**FILE** P.I. #0002850 **OFFICE** Design Policy & Support  
STP00-0002-00(850)  
GDOT District 7 - Metro Atlanta  
Cobb County **DATE** March 28, 2011  
CS 1621/Roswell St from Waddell St to  
Rock St – Phase I - LCI

**SUBJECT** APPROVED REVISED CONCEPT REPORT

**REVISED PROJECT CONCEPT REPORT**

Project Number: STP-0002-00(850)  
County: Cobb  
P. I. Number: 0002850  
Federal Route Number: -NA-  
State Route Number: -NA-

ROSWELL STREET, TYPICAL SECTION B-1  
 THE CITY OF  
 MARIETTA, GEORGIA

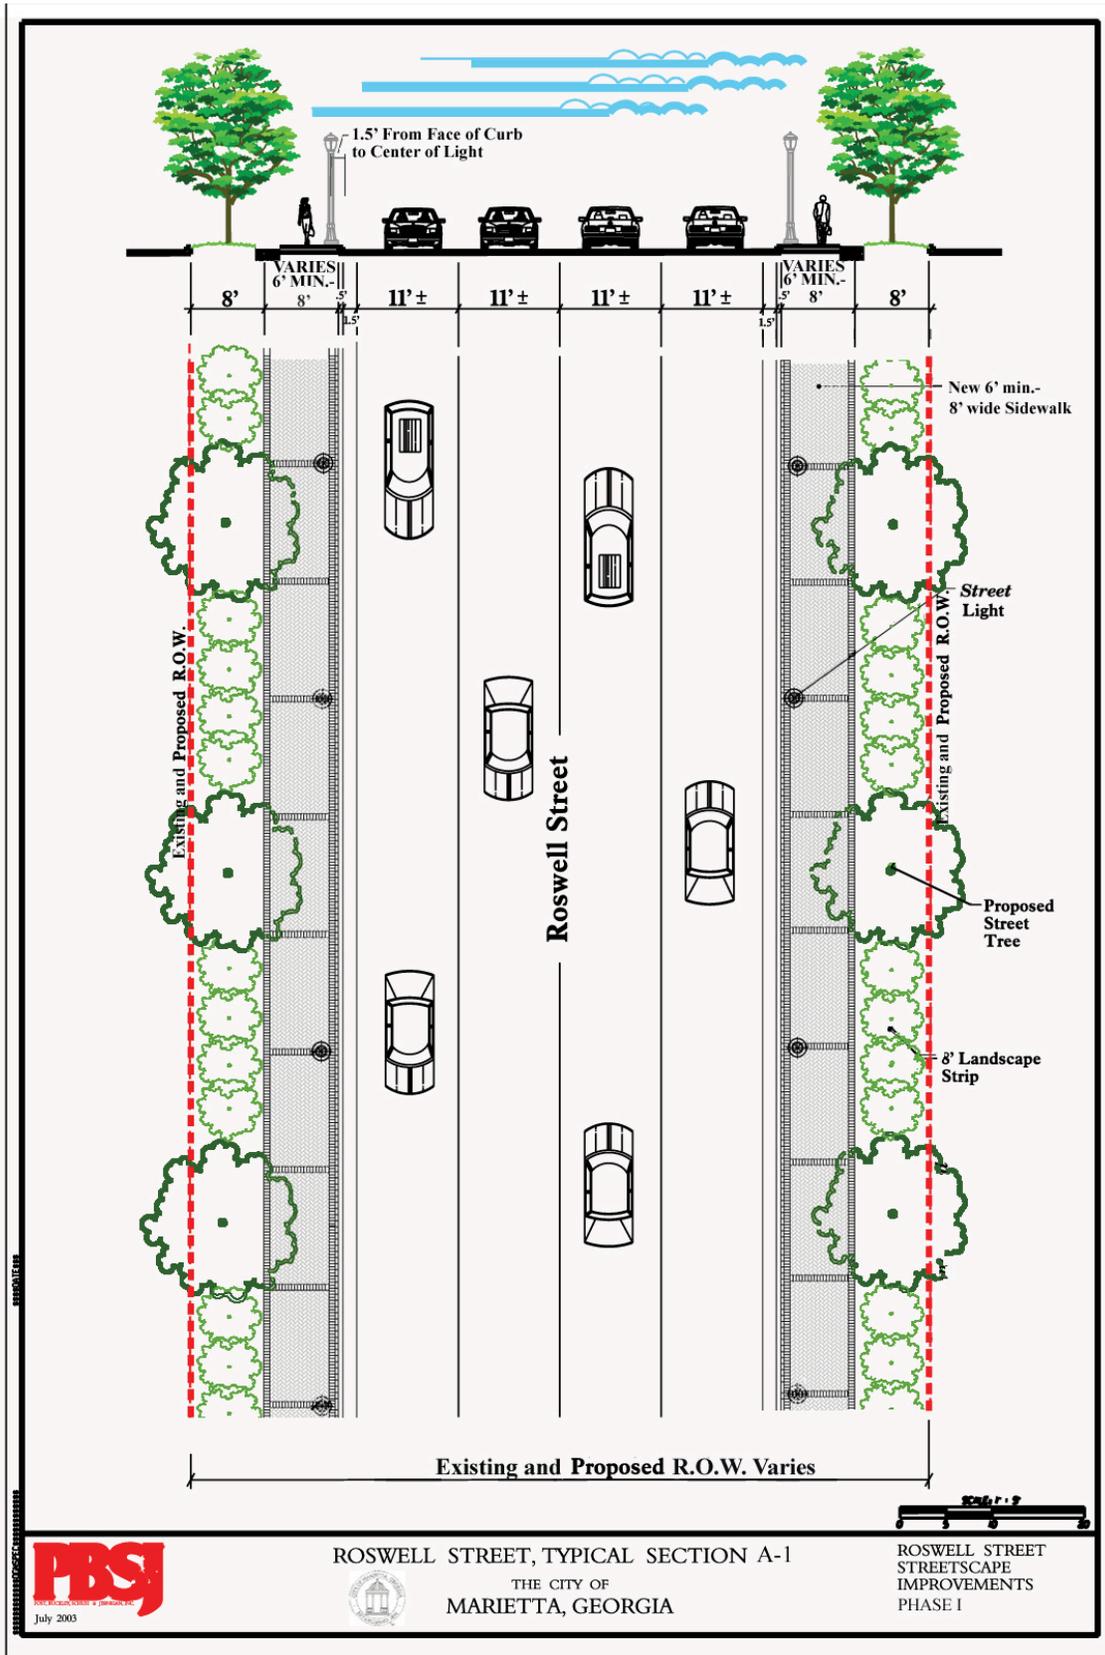
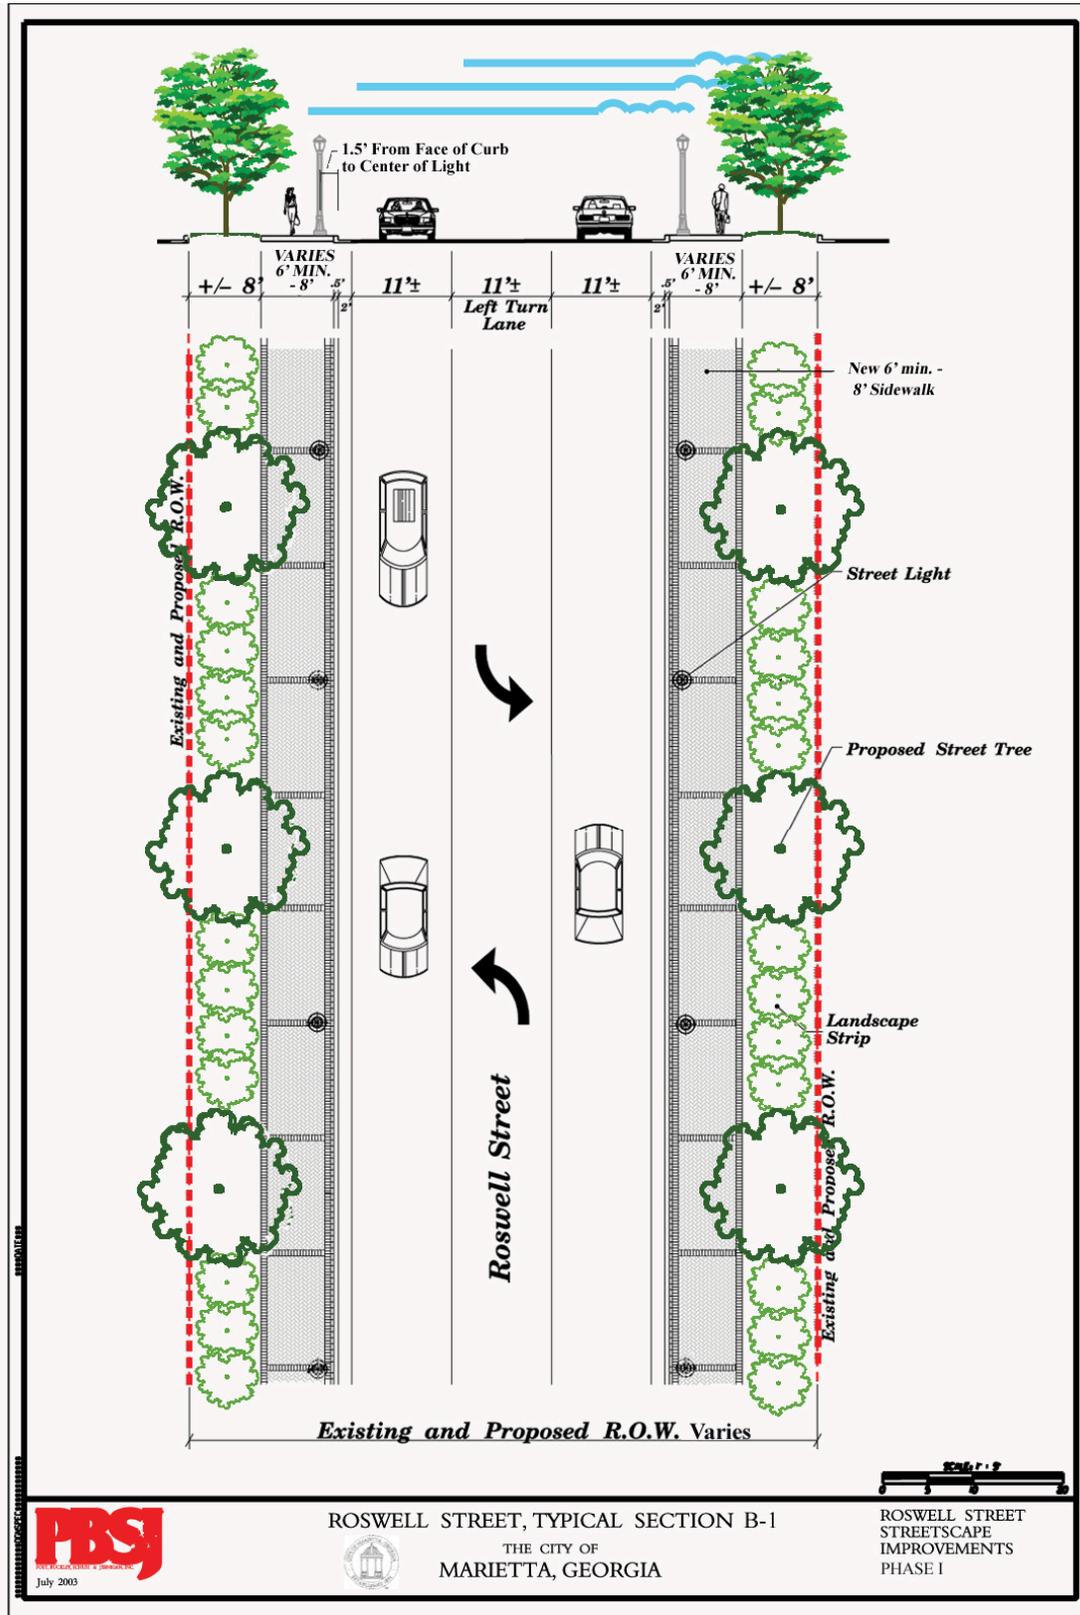
Construct six minimum to eight foot wide sidewalks with decorative pavers, landscaped areas, lighting, ornamental signage, and seating areas. No Right of-Way or easements including any landscape, driveway, or temporary construction will be acquired for this project. All sidewalks will follow ADA general guidelines and comply with the standards of the City of Marietta and Georgia Department of Transportation.

**Reason for Change:** The City of Marietta has removed all streetscape improvements that require easements and R/W acquisition from the Roswell Street Streetscape Phase I project in order to expedite the Georgia Department of Transportation and Federal Highway approval of construction funding prior to June of 2011.
